**Subject: East/West Circulation Alternatives Analysis Comments
Kinston Terrace Master Plan
King City, Oregon**

In accordance with your request, the following outlines our technical review comments of the East/West Circulation Alternatives Analysis – Draft (dated July 2022) for the Kingston Terrace Master Plan (the report). Our responses follow the categorical structure of the original report. We have provided suggested alternative scoring that reflects our findings where we deviate from the draft report.

Thank you for the opportunity to comment on the Kingston Terrace Master Plan “East/West Circulation Alternatives Analysis – Draft” July 2022. The comments are meant to be constructive and are made on behalf of myself and my brothers. We are the owners of a 42-acre farm known as Sharlin Farm, it is located East of Elsner Rd. between Beef Bend Rd and the Tualatin River. The furthest West of the stream crossings discussed in the Master Plan is mostly on our property.

Figure 14. East/West Circulation Alternatives

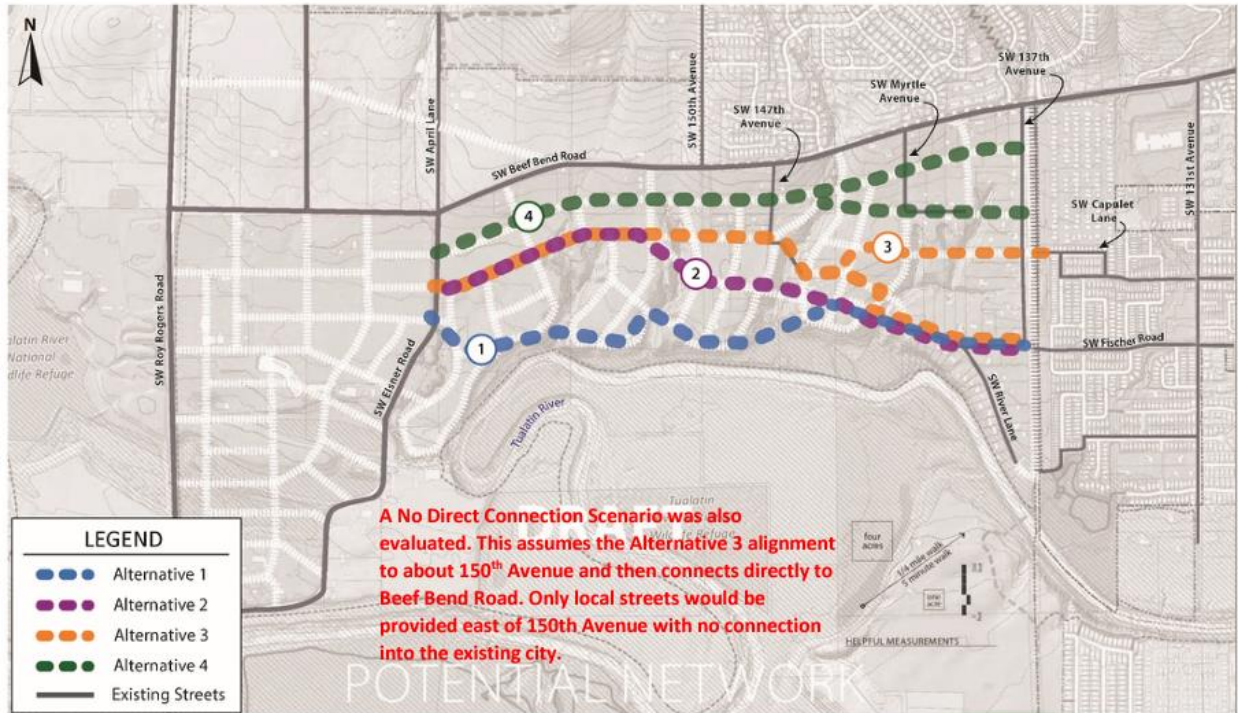
For clarity purposes, the Transportation Analysis describes the Alternative 4 alignment as “... run[ning] parallel to and approximately 300 feet south of Beef Bend Road.” This alignment further includes northern and southern alternatives on the eastern portion of the alignment which are all graphically depicted in Figure 14, above. Based on the graphical information that also includes a conceptual *Local* roadway layout, Alternative 4 is the most direct, and least circuitous alignment between Elsner Road (in the west) and SW 137th Avenue (in the east) of all the alternatives. As such, it is incorrect for the Transportation Analysis to conclude that Alternative 4 is “[m]ore circuitous than [Alternatives] #1, #2, or #3 to reach destinations in [the] existing city”, or that it provides a “[m]ore circuitous connection between east and west of city”, or that the alternative is “[t]oo circuitous, likely to rely on Beef Bend Road for TriMet service” without clearly articulating the evaluation criteria – which appears to be focused the ability to directly travel between origin-destination pairs C and D illustrated in Figure 12, above.

Figure 1.
Kingston Terrace East-West Alternatives Analysis,
Western Ravine Crossing Locations

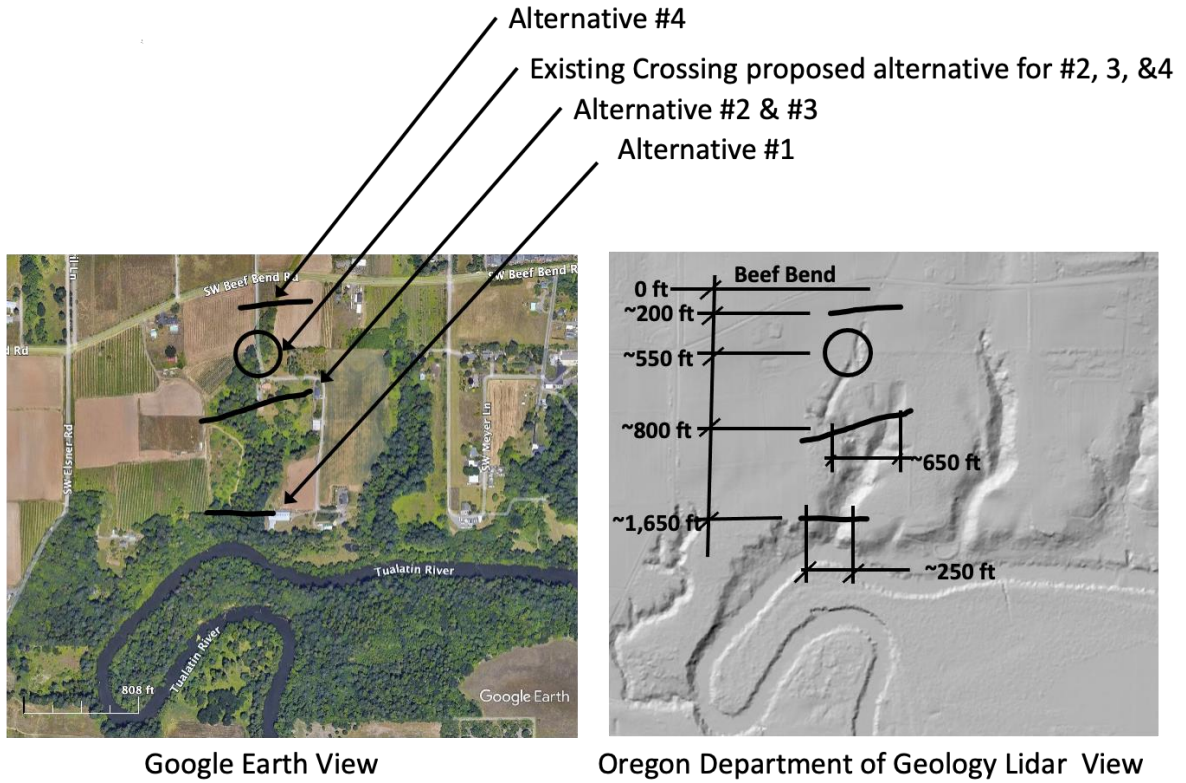
Regarding the 4 East/West route options shown on Figure 5 of the analysis and the crossing of the Western most ravine:

Please refer to the annotated Google Earth image and the Oregon Department of Geology Topographical Lidar image shown in Figure 1 below.

- Alternative 4 crosses North of the deep ravine and could be done with a culvert as opposed to a bridge. Both cost and environmental impact would be minimum. The disadvantage of Alternative 4 is that it is close to Beef Bend and creates a relatively narrow strip of land that will be dysfunctional and difficult to develop. We recommend moving Alternative 4 to the South but still above the wider and deeper ravine areas.

- **Alternative X the Existing Crossing.** Between the crossing location proposed for Alternative 2&3 and the one proposed for Alternative 4 is an existing crossing. It is roughly 550 ft. South of Beef Bend at a point where the ravine is still narrow and not very deep. The crossing consists of nothing more than a buried 30-inch diameter culvert. It is our recommendation that Alternative 2, 3 and 4 be re-aligned to a single crossing point at or near the site of the existing crossing. The crossing could be rebuilt with a culvert, no requirement for a bridge, and the location is at a point where the ravine is still narrow and not too deep (about 15 ft deep). In our opinion, rebuilding this crossing will be a low-cost option and have the minimal environmental impact. [Note that the second ravine from the West (near 150th Ave) has similar potential for a culvert crossing at roughly the same distance south of Beef Bend Rd.]

2. The Western most stream crossing (shown on Figure 5 of the analysis) for Alternatives #2, 3 and 4 can be re-aligned and consolidated into a single option that is located approximately 550 ft. South of Beef Bend Rd. This is the site of an existing crossing. The existing crossing is a single lane gravel road over a 30” culvert. Replacing it with a longer culvert for 2 or 3 lanes would be a functional, low cost and environmentally attractive alternative. We recommend this option.
